ADDENDUM No. 3
FOR
LINK – Multi-Use Development
BID PACKAGE – All Trades

Date of Issue: April 24, 2023

LINK – Addendum #3 Narrative

4/21/23

WALL CONST. @ STAIR
- APPLIED BITUMINOUS DAMPROOFING ON FACE OF CONCRETE/MASONRY WALL
- 1" RIGID INSULATION
- 1" AIR SPACE
- BRICK VENEER (SEE ELEVATIONS FOR EXACT BRICK TYPE)

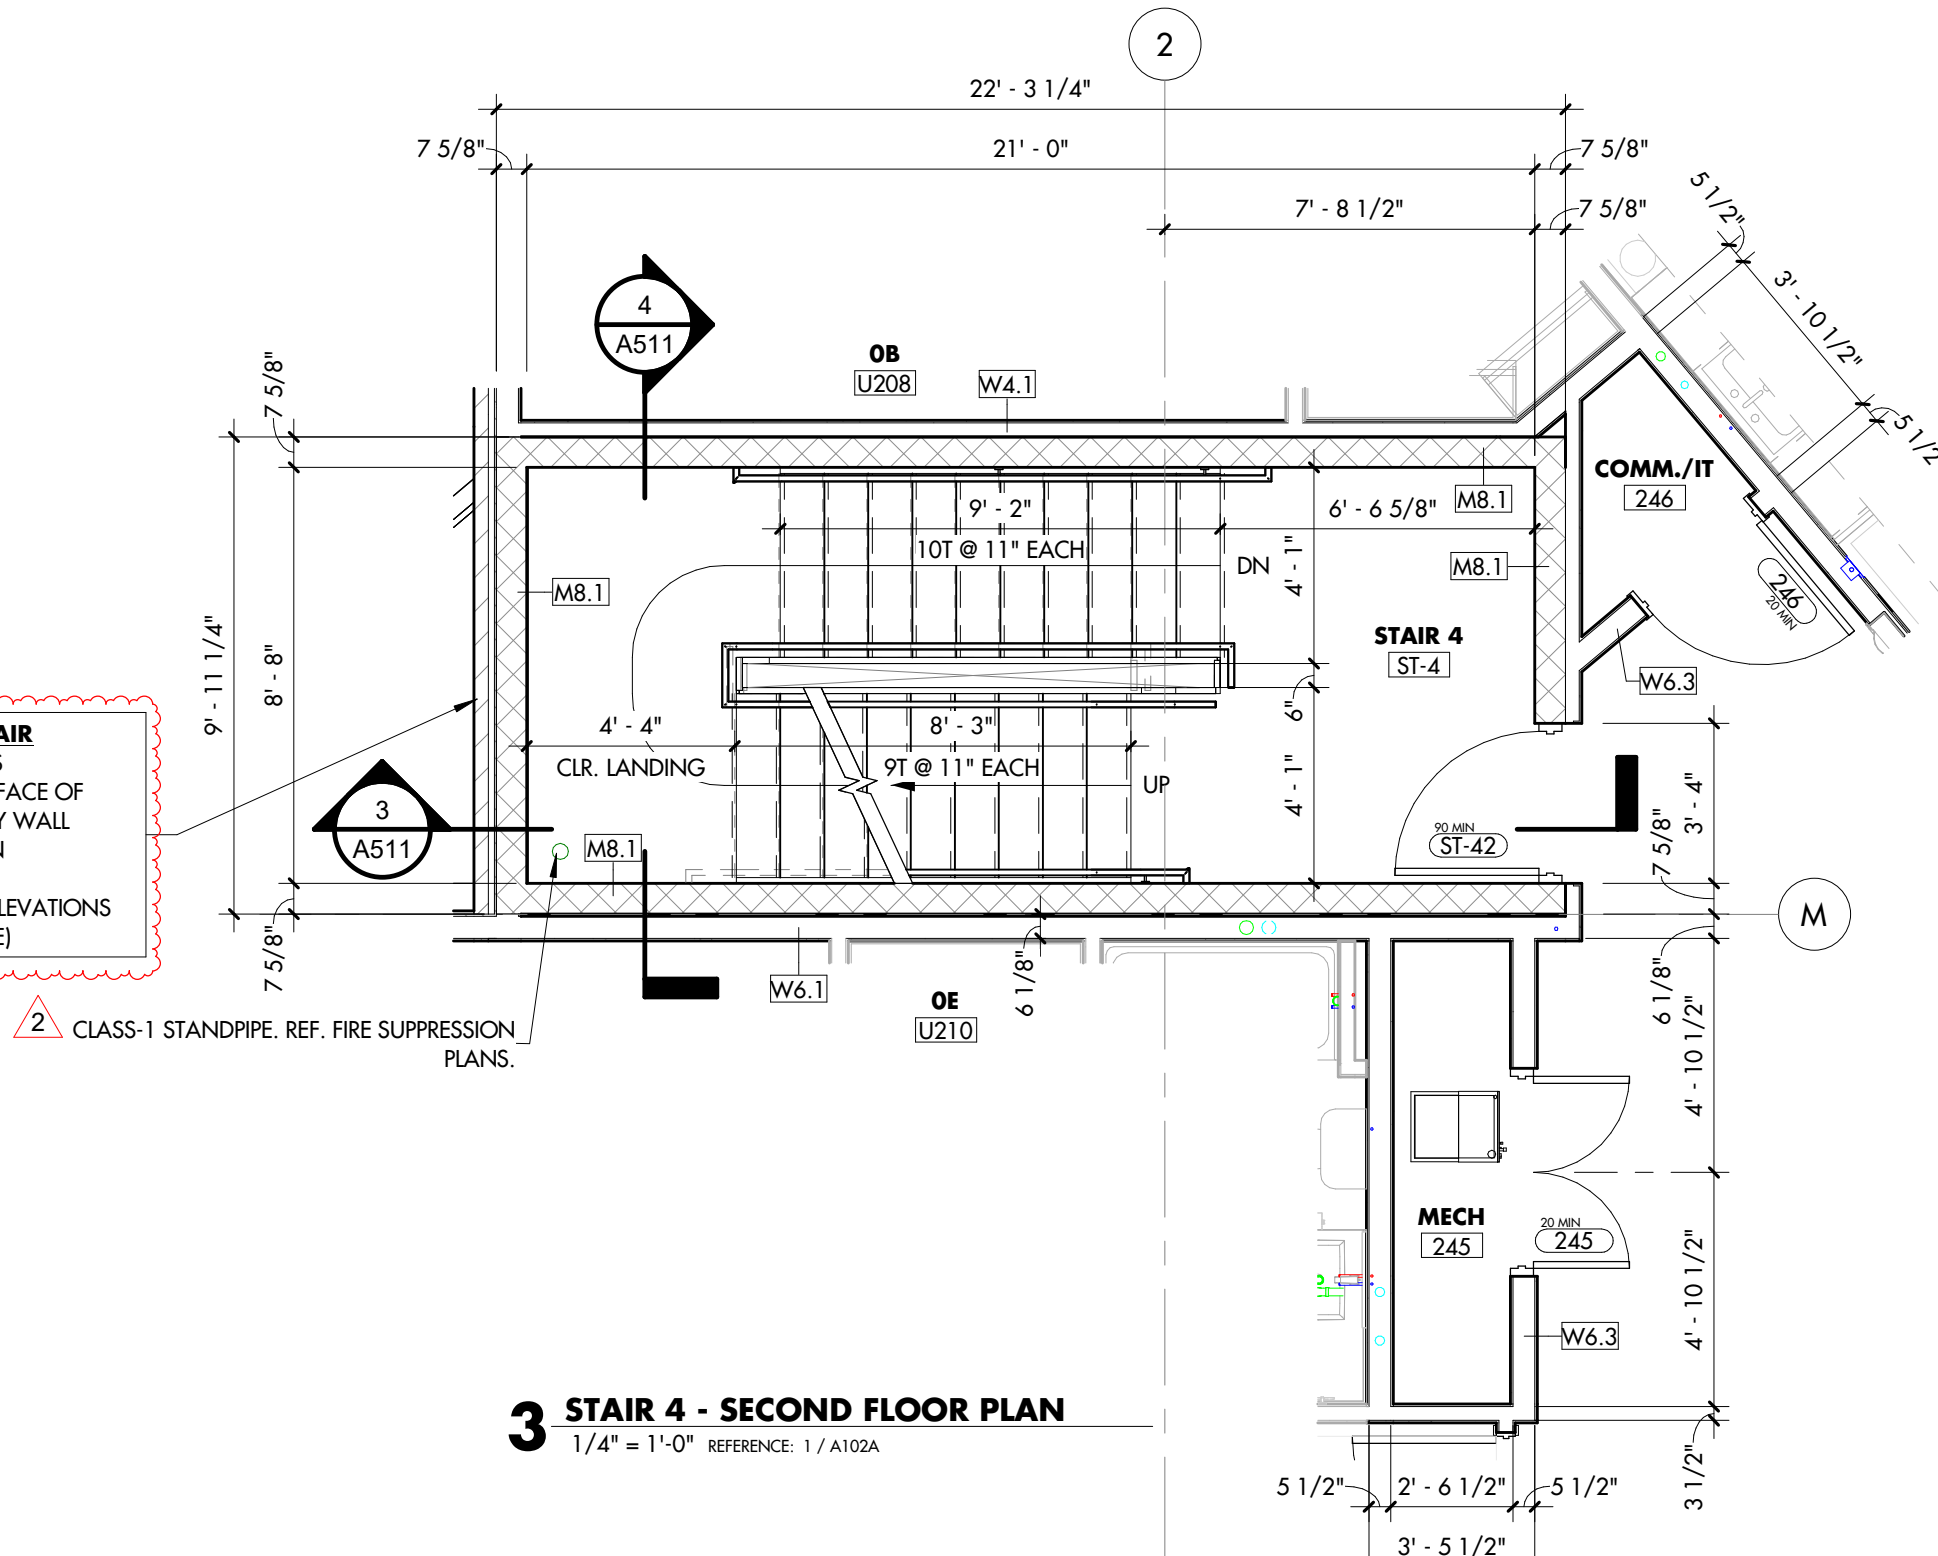
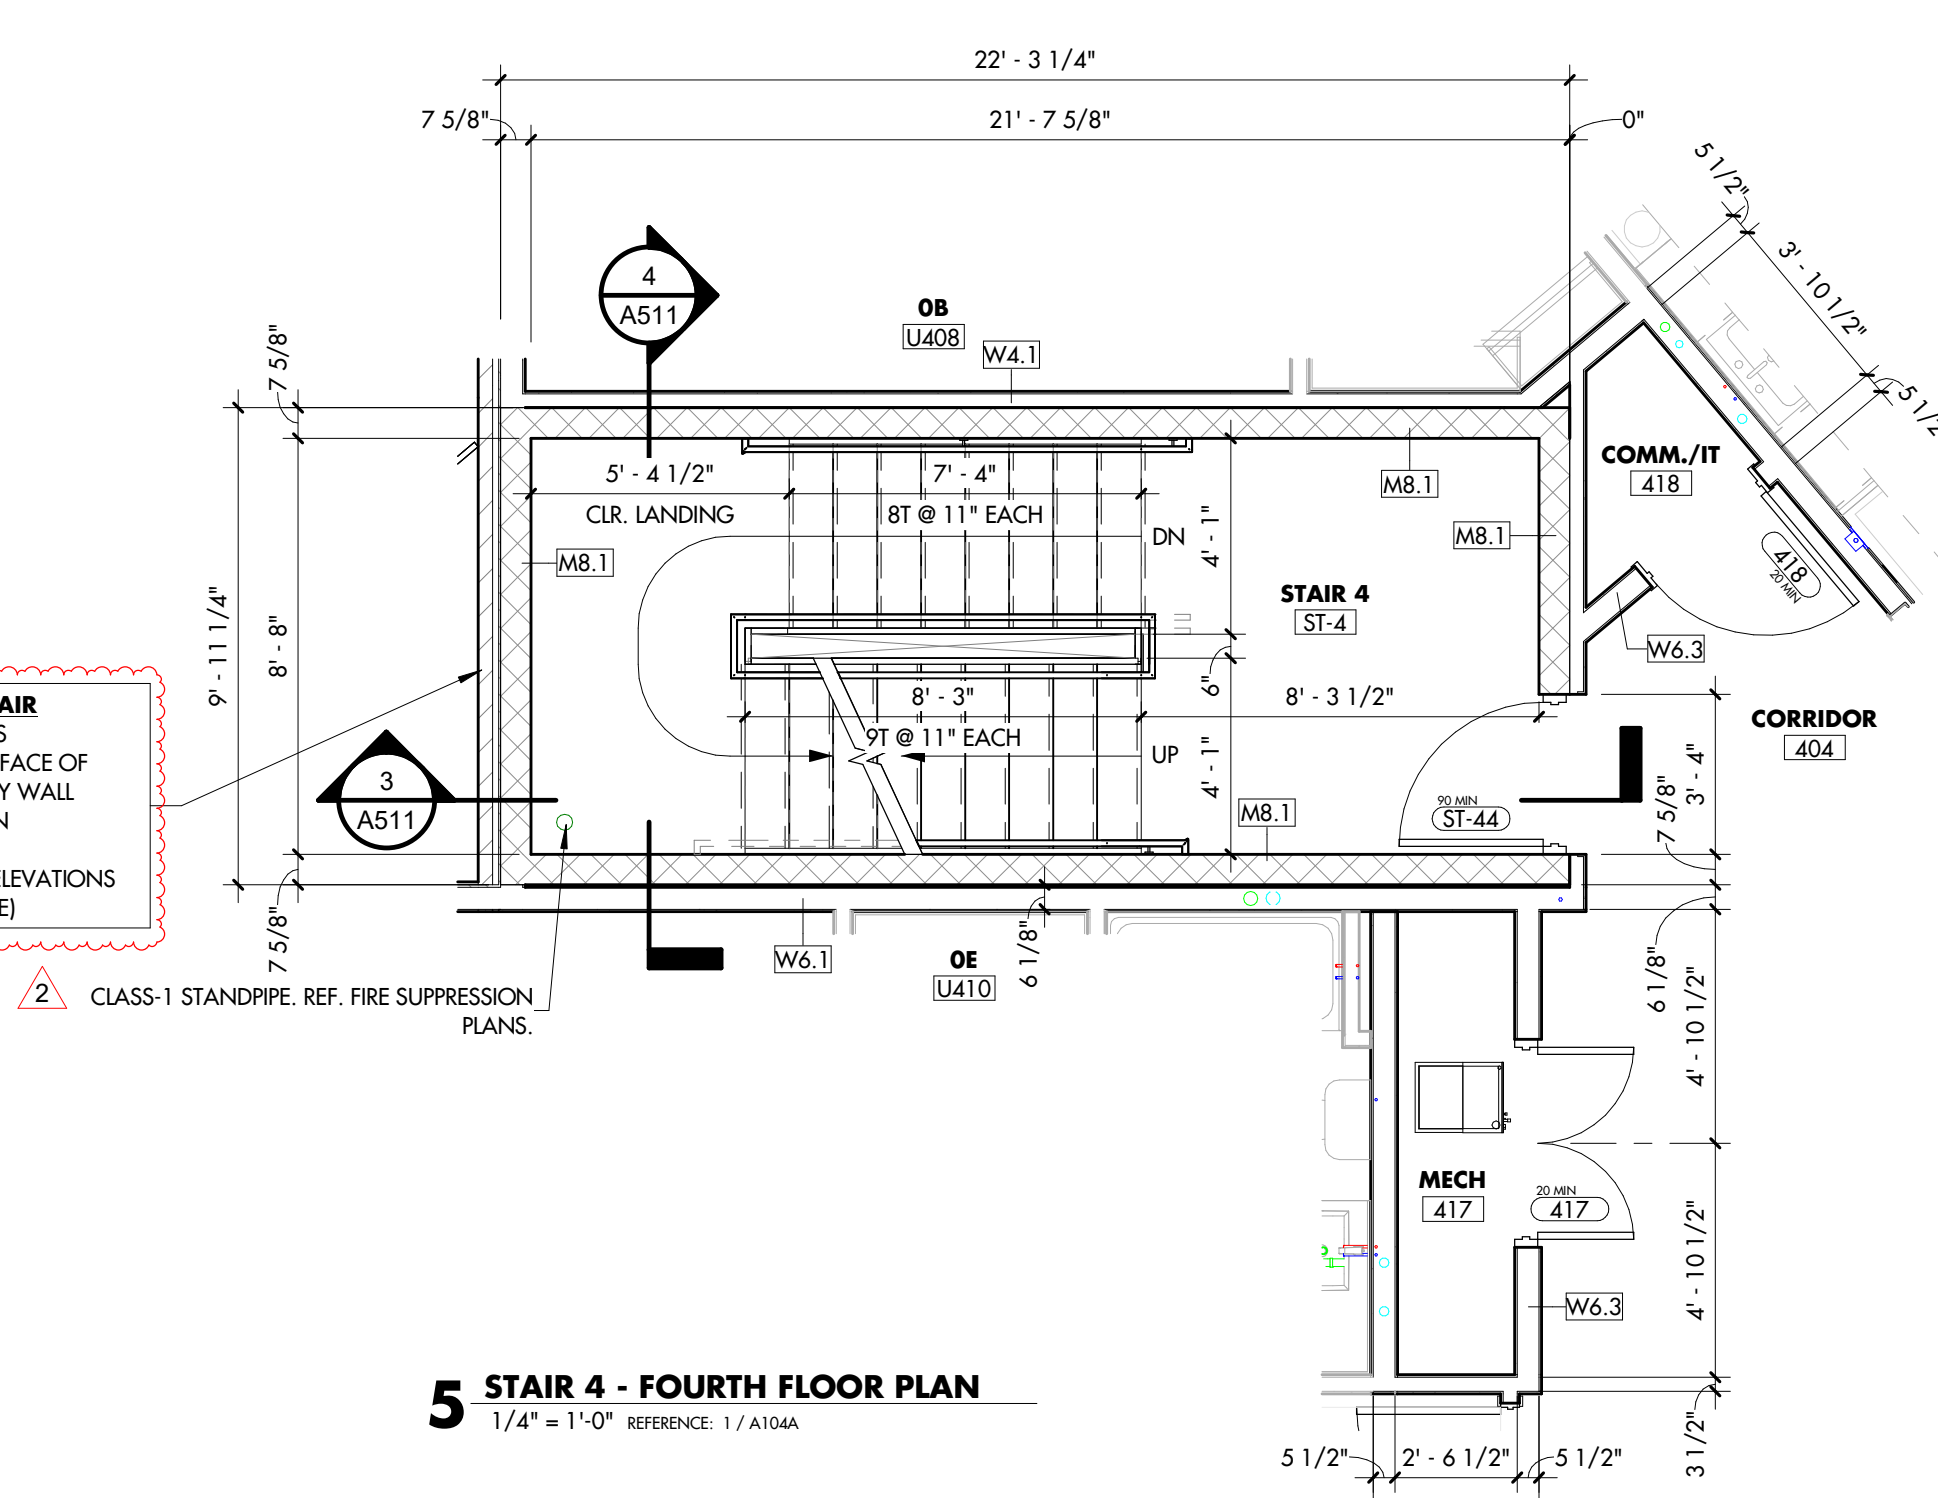
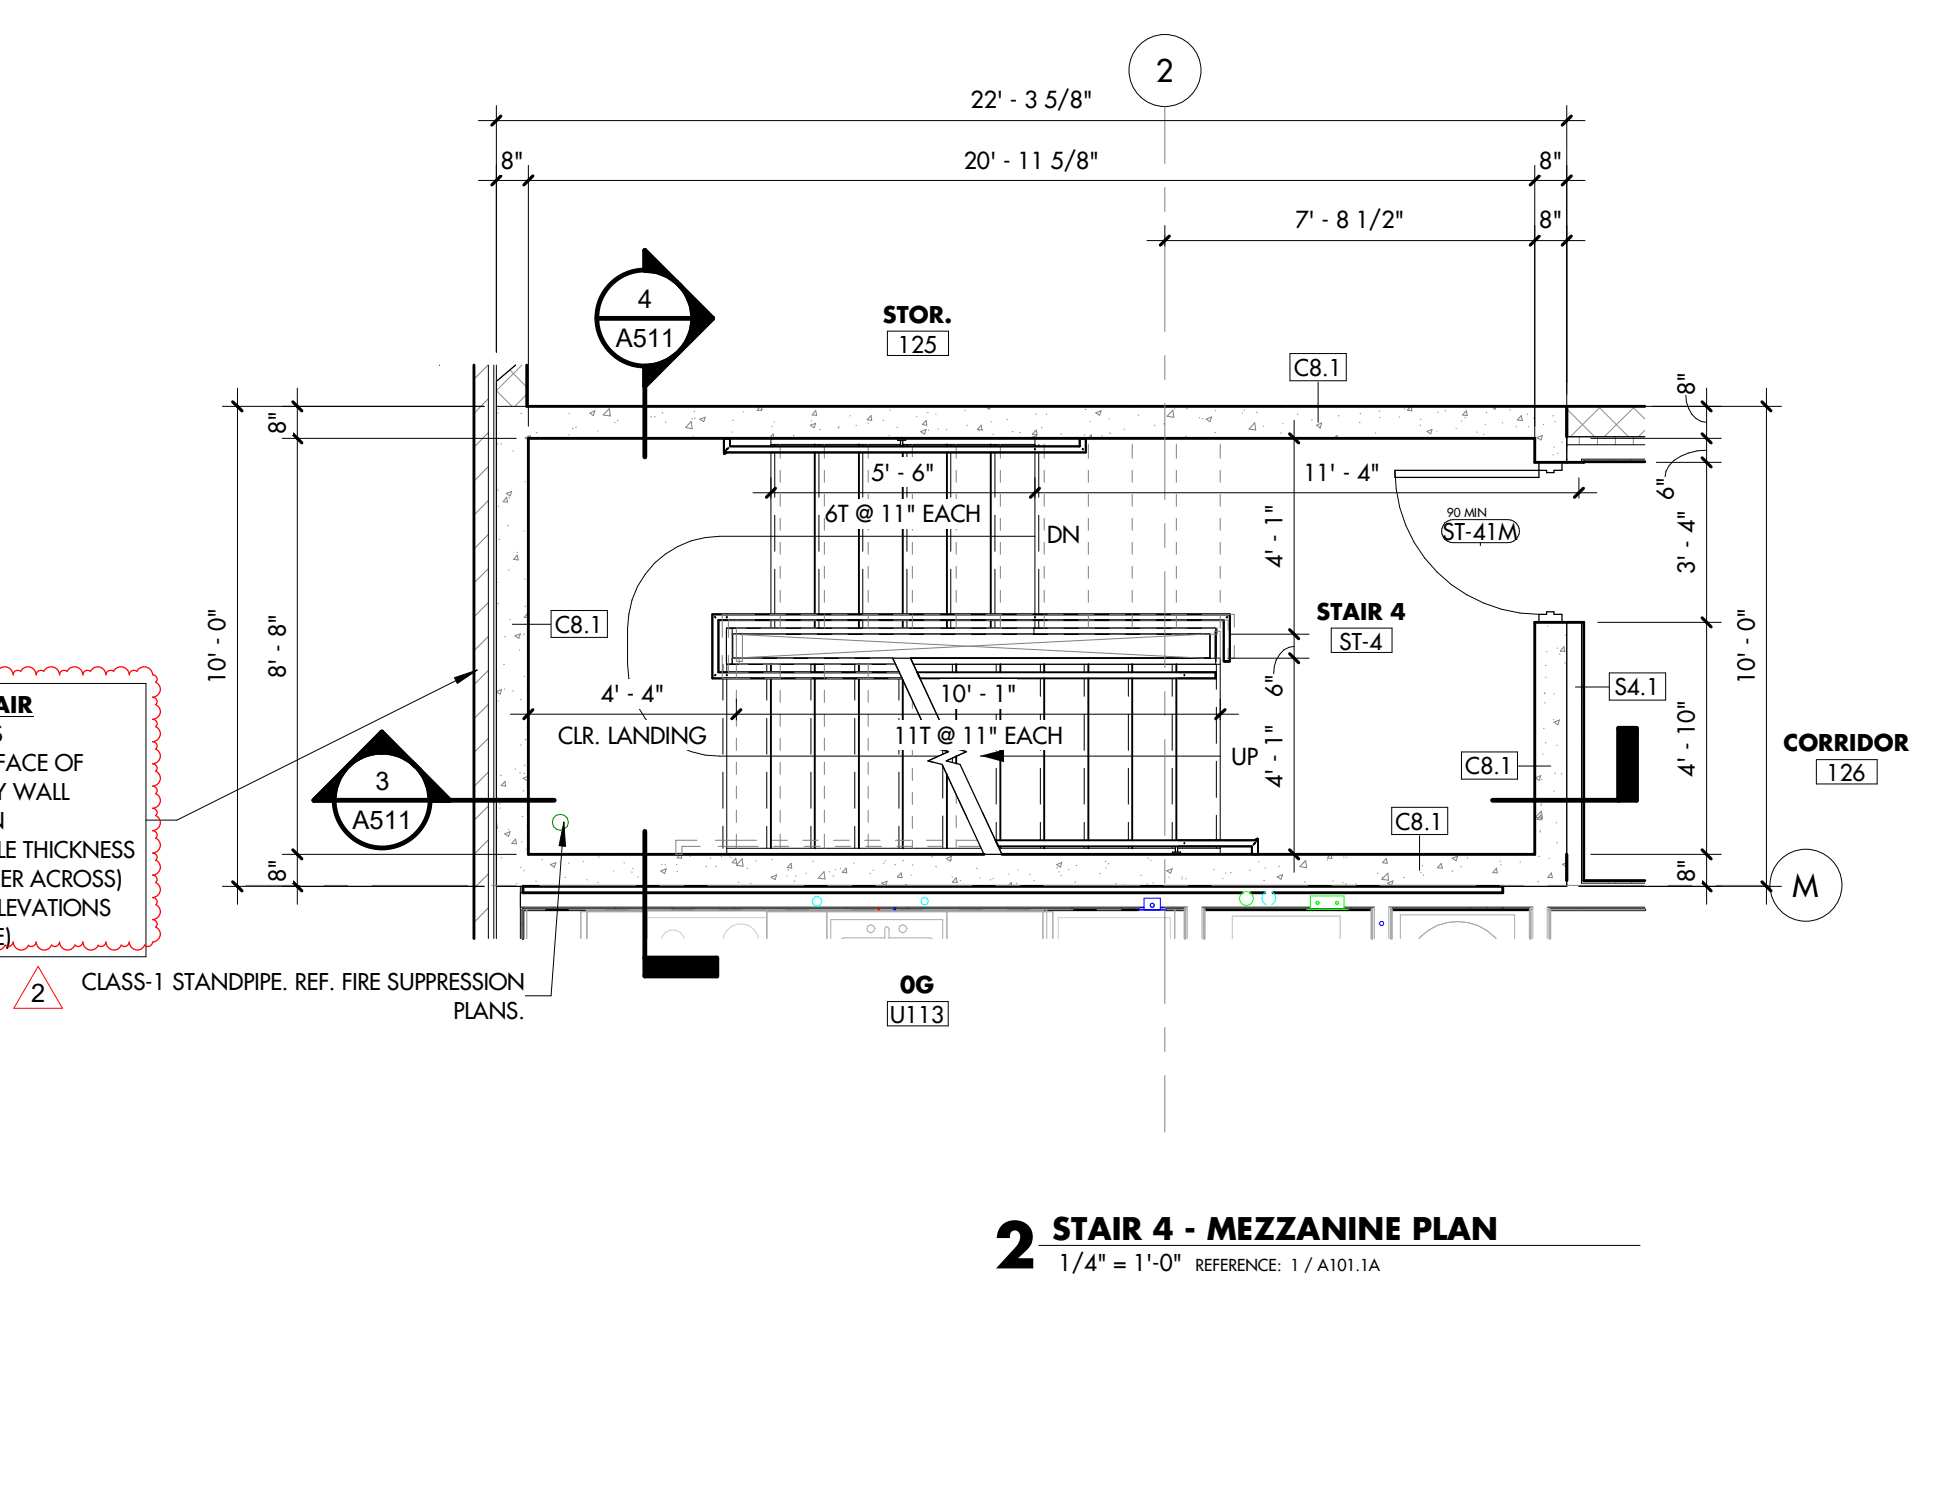
- A504
 - Clarified exterior wall construction at stair.
- A601
 - Revised door finishes.
- A602
 - Revised door finishes.
 - Revised pre-hung unit door heights.
